Work Order ID 112783

Item Name: Crosstube Turning Detail

DART AEROSPACE LTD	Work Order:	112783
Description: Crosstube Assembly (205/212 High Aft)	Part Number:	D212-664-241
Inspection Dwg: D212-664-241 Rev: D		Page 1 of 2

DRAWING NO. D212-664-241	TITLE CROSSTUBE ASSY (205/212 HI AFT)	REV. D	DART AEROSPACE LTD ENGINEERING ORDER		D.E.O. NO. D212-664-241-D-1	SHEET NO. SHEET 1 OF 2	SCALE NTS
DRAWN	CHECKED	MFG. APPR.	APPROVED	DE APPR.			
DATE 11.04.07	DATE 11.04.11	DATE 11.04.12	DATE 11/04/12	DATE 11.04.12

**D212-664-241/-241B
ASSEMBLY DETAIL**

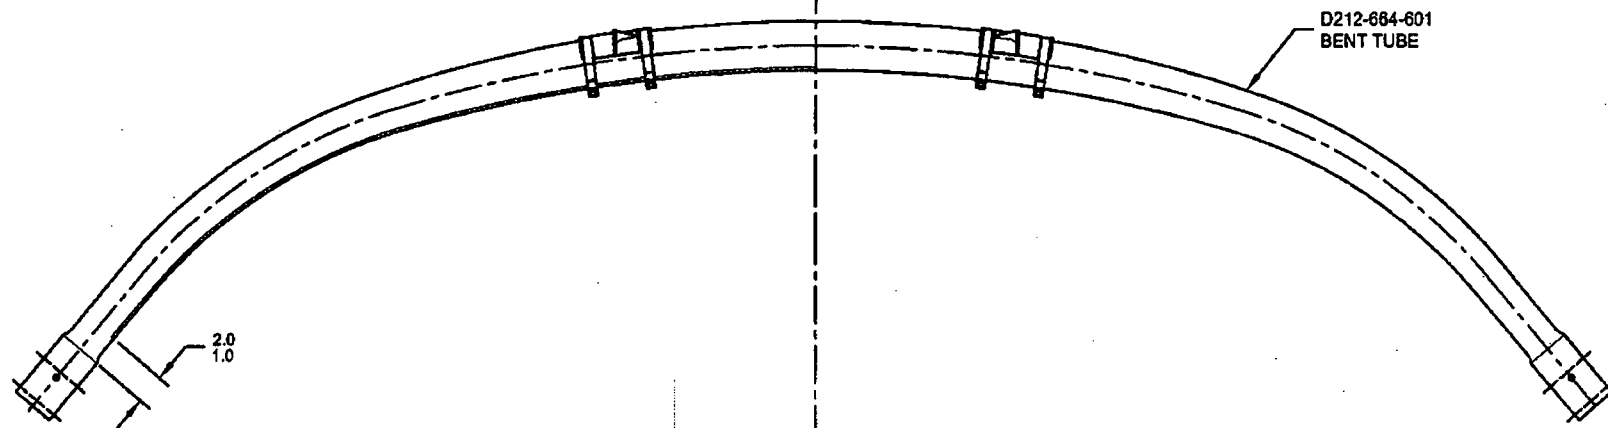
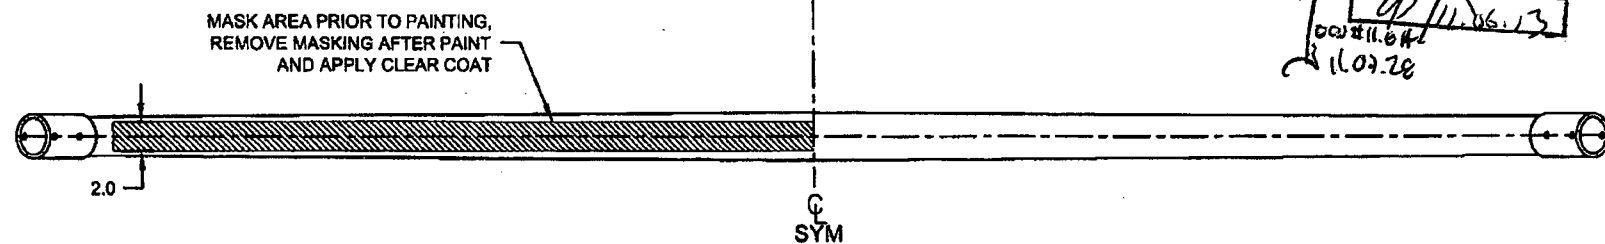
PURPOSE:

ADD AN INSPECTION WINDOW TO UNDERSIDE OF CROSSTUBE.

NOTES 2 OF SHEET 1 IS AMENDED AS FOLLOWS:

IS:

- 2) FINISH: CHEMICAL CONVERSION COAT PER DART QSI 005 4.1
PRIME INSIDE AND OUTSIDE PER DART QSI 005 4.2
MASK UNDERSIDE OF CROSSTUBE AS SHOWN (HATCHED AREA) AND
PAINT OUTSIDE PER DART QSI 005 4.2
REMOVE MASKING AND APPLY CLEAR COAT
